LINCOLN PARK STADIUM IMPROVEMENTS
GRAND JUNCTION, CO

**AISLE COATING REVISION
 LINCOLN PARK STADIUM IMPROVEMENTS**

ADDENDUM #1

A7.20

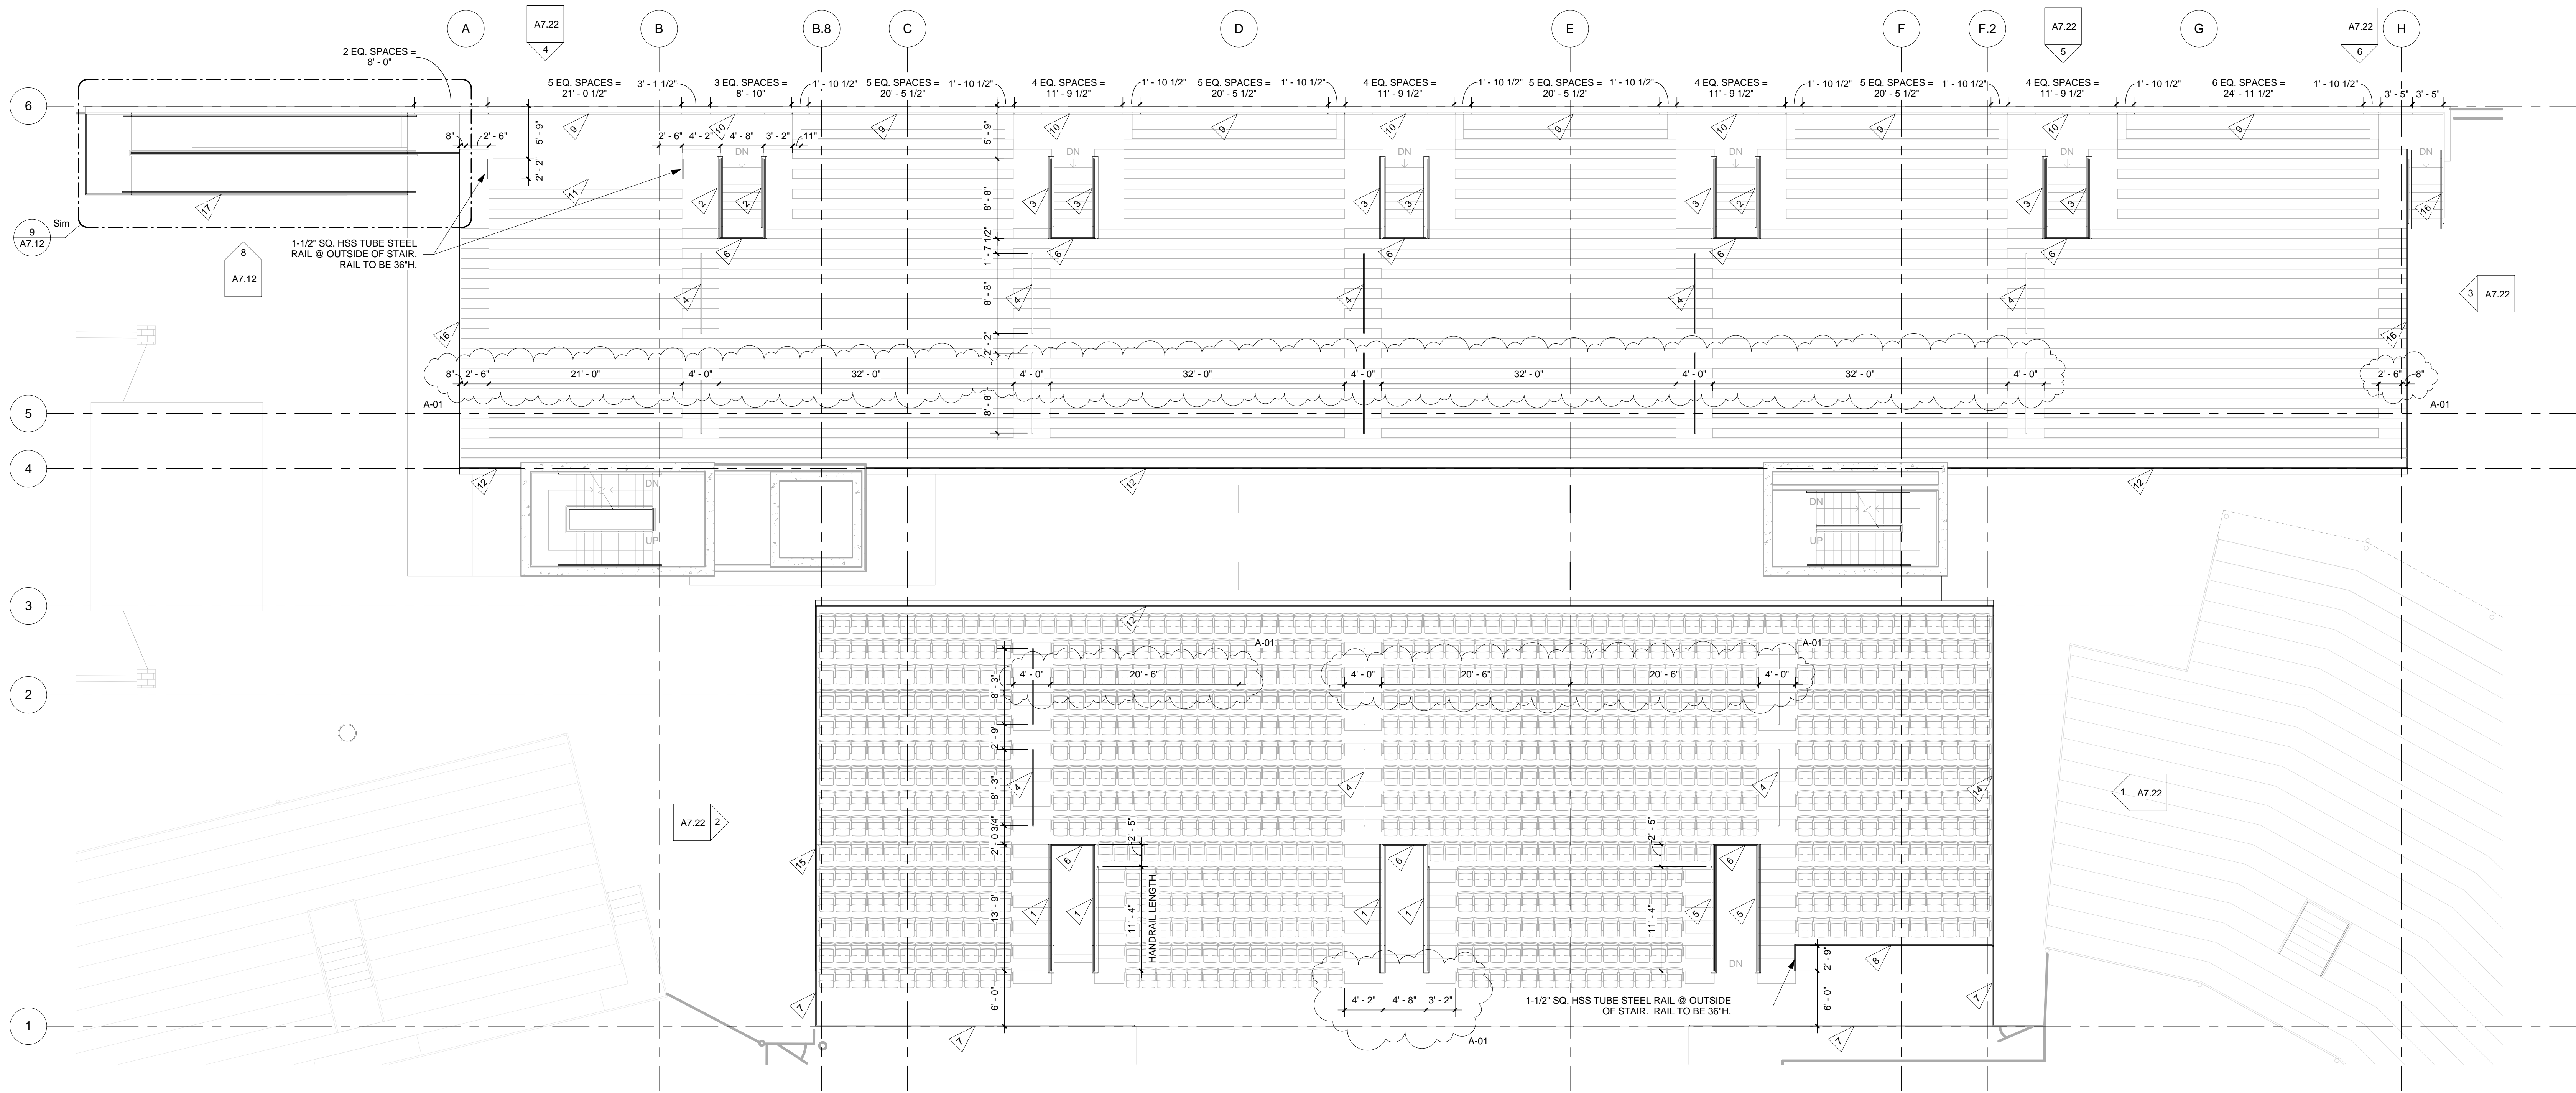
- 1 BASEBALL VOMITORY GUARDRAIL/HANDRAIL. REFER TO DETAIL 1/A7.21 FOR INFORMATION. REFER TO PLAN FOR LENGTHS.
- 2 FOOTBALL VOMITORY GUARDRAIL/HANDRAIL. REFER TO DETAIL 2/A7.21 FOR INFORMATION. REFER TO PLAN FOR LENGTHS.

- 3 FOOTBALL VOMITORY GUARDRAIL/HANDRAIL W/ RAKER BEAM. REFER TO DETAIL 3/A7.21 FOR INFORMATION. REFER TO PLAN FOR LENGTHS.
- 4 TYPICAL AISLE RISERS/HANDRAIL. REFER TO DETAIL 4/A7.21 FOR INFORMATION. REFER TO PLAN FOR LENGTHS.

AX-01.1

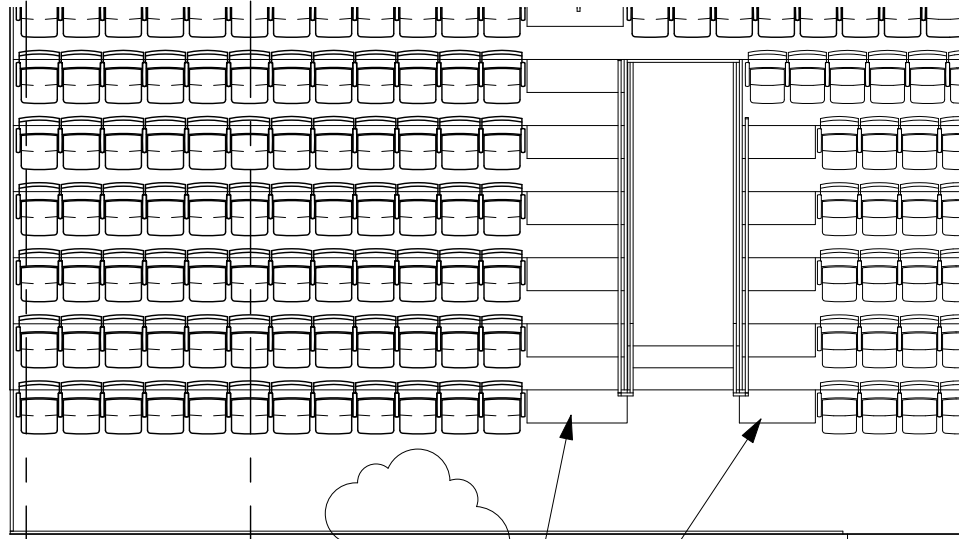
12	AX-01.1 AX-01.2	071800 / 099600 / A2.20	Q: Spec section 071800 Traffic Coatings – the product specified is identified on the drawings as being applied primarily to the HC seating areas of the steel framed seating areas on both the baseball & football grandstands. This product is not likely compatible with the High Performance paint system called for on the steel grandstand surfaces. Also, this product is called for on the concrete walkway section behind the 1st base dugout. This does not appear to be a necessary application. A: Specification 071800 - Traffic Coatings is deleted from the project requirements. No coating is to be provided to the concrete at the bottom of the baseball seating area. The concrete shall have a light broom finish per 033000/3.11/E. Per specification 099600/2.2/A/1 "NON-SKID" high performance coatings with additive for slip resistance are to be provided at all walking surfaces in the grandstand seating areas. See attached revision sketch AX-01.1 & AX-01.2.

A-01
 PROVIDE NON-SKID H.P.P. AT ALL STEEL SEATING SECTION SURFACES INCLUDING AISLES, CROSS AISLES, LANDINGS & STAIRS, TYP.
